Service Letter

SL07-474/JJP
March 2007

Lifting Tool for Crosshead Bearing Cap 80-98MC/MC-C and ME/ME-C Engines

Encl.: S904-0008

Fig. 1: Lifting tool for K98MC-C

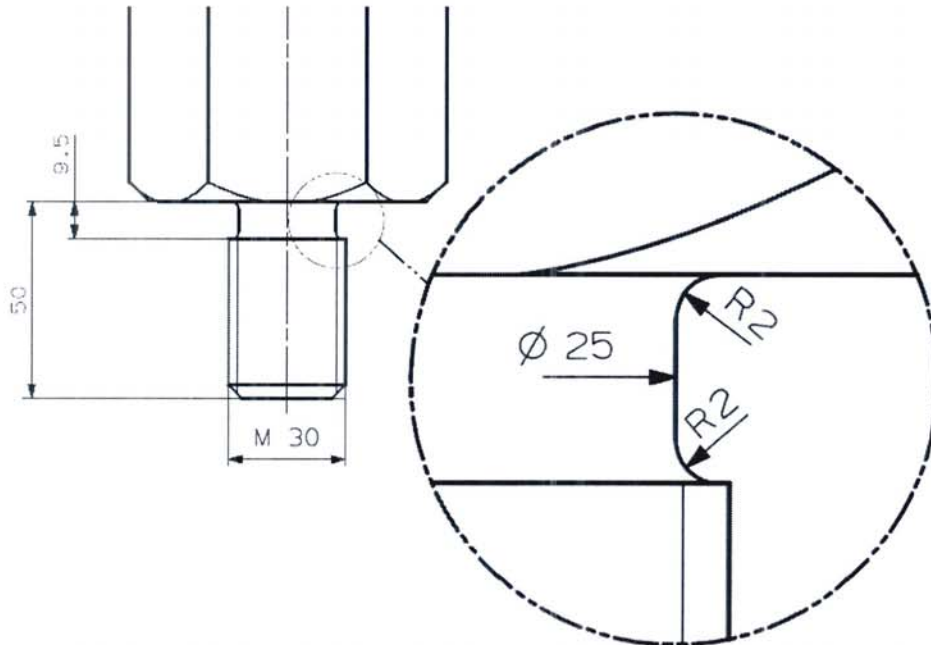
We recommend engine crews to check the fillets on the lifting tools, see Fig 1.

If an insufficient fillet or signs of cracks, bending or other misuse is found, we strongly recommend to discard the extension stud and order a new one, either from the engine builder or from MAN Diesel A/S, PrimeServ in Copenhagen.
